**Re: Proposed Warehouse Development  
UW Vintage Lane II, LLC  
25 Talbot Lane  
South Windsor, Connecticut  
Our File: 22010**

On behalf of our client, UW Vintage Lane II, LLC, our office has conducted a peer review of the Traffic Impact Study for the proposed Warehouse Development located at 25 Talbot Lane, dated January 2022 prepared by Langan. We have also reviewed the original and revised site plans that have been submitted for site plan approval. This letter presents our findings.

**LEFT TURN LANE WARRANT  
ANALYSIS WORKSHEET**

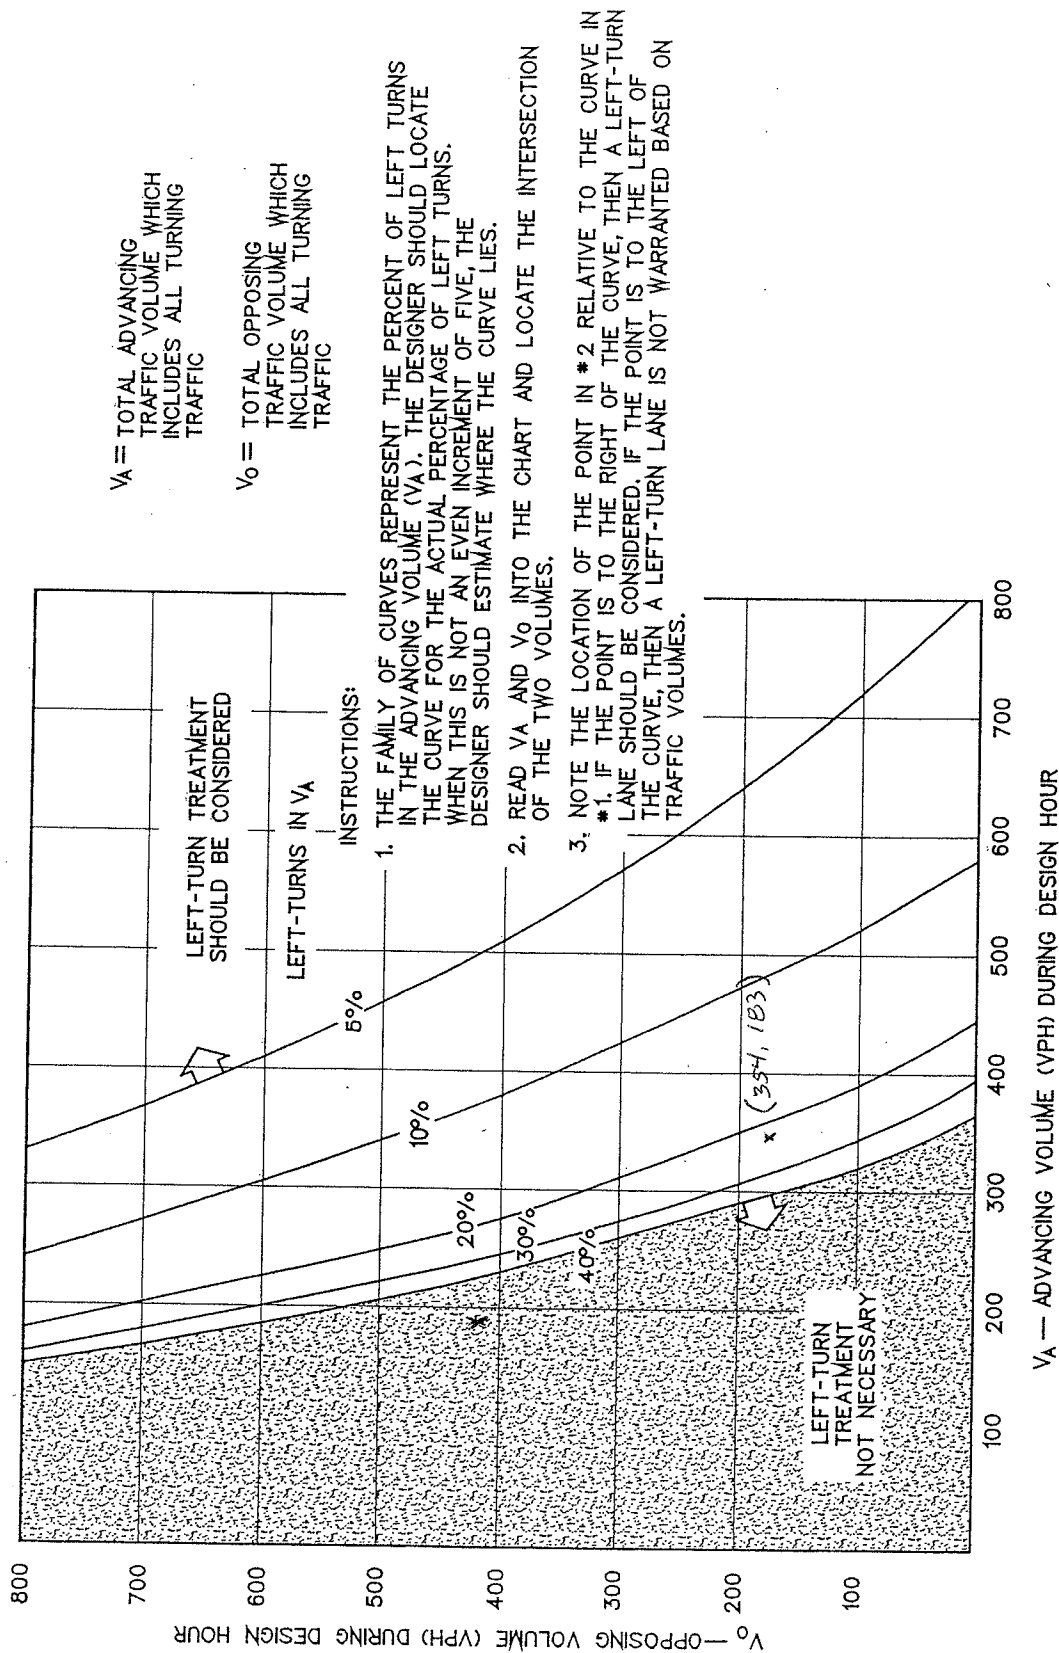
Our office has completed a left turn lane warrant analysis for the proposed site driveway intersection for the morning and afternoon peak hours, and we have determined that a left turn lane treatment is not warranted. Based on the calculated levels of service and the projected volume of left turn movements, it is our opinion that a by-pass capability is not required either.
